CHANGE ORDER NO. 14

PROJECT:	<u>Horizon City Municipal Facilities Phase I</u>	DATE OF ISSUANCE:	January 27, 2026
OWNER:	TOWN OF HORIZON CITY 14999 Darrington Rd. Horizon City, Texas 79928	EFFECTIVE DATE:	January 27, 2026
CONTRACTOR:	<u>Dantex General Contractors</u> <u>4727 Osborne</u> El Paso, TX 79922	ARCHITECT:	Eugenio Mesta, AIA Exigo Architects 211 N. Florence Ste. A El Paso, Tx 79912
CONTRACT FOR:	<i>New Municipal Facilities for the City of Horizon</i>	OWNER'S BID NO.	CSP 23-038 Project No. 2.513D
		ARCHITECT'S PROJECT NO:	20201600

TITLE: Additional Power and Data Drops per ASI #07

To: DANTEX Construction
From: Jesus Ortega, EXIGO Architects
Project: HCMF
Date: November 13, 2025
Re: **ASI 007 – New Power and Data request**

1 POWER PLAN SECTION A
1/8" = 1'-0"

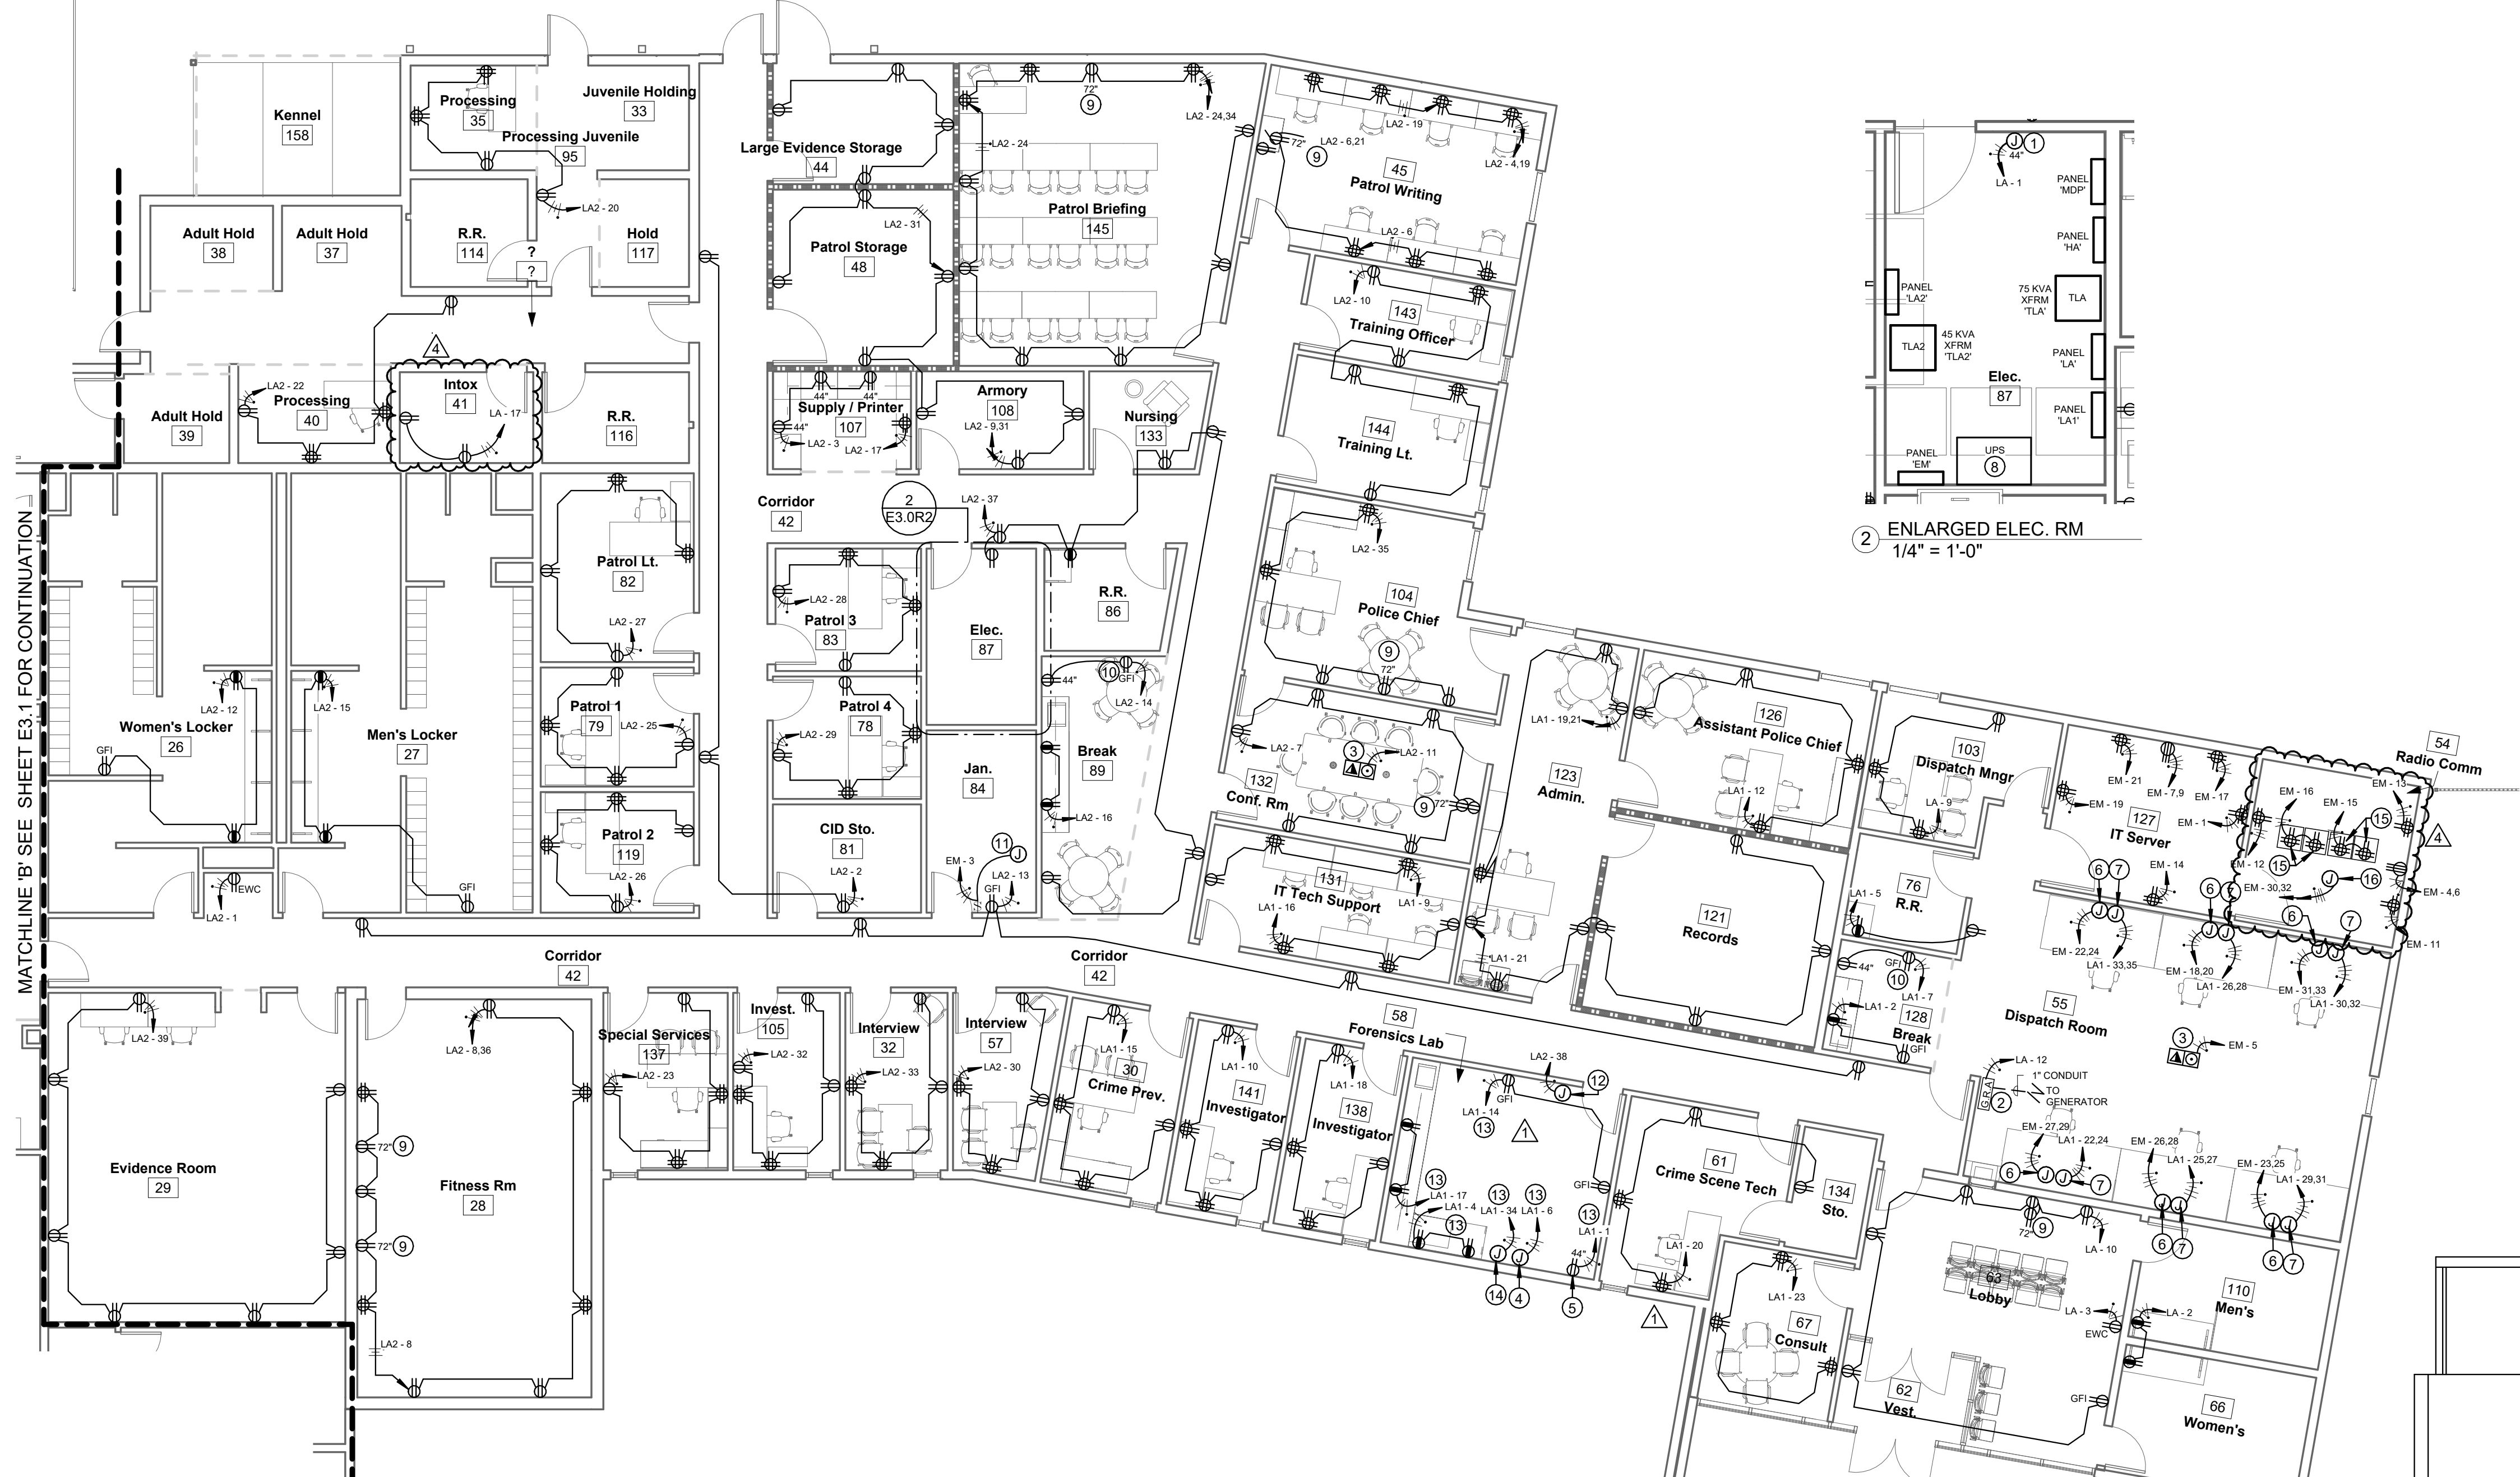
The Town of Horizon is requesting additional power and data drops at different locations.

- a) ASI 007 – E3.0R2 – Delta#4: Power Plan “A”_
- b) ASI 007 – E4.0R3 – Delta#4: Special Systems “A”
- c) ASI 007 – E4.1R1 – Delta#4: Special Systems Plan “B”
- d) ASI 007 – E6.0R2 – Delta#4: Panel Schedules
- e) ASI 007 – E6.1R1 – Delta#4: Panel Schedules
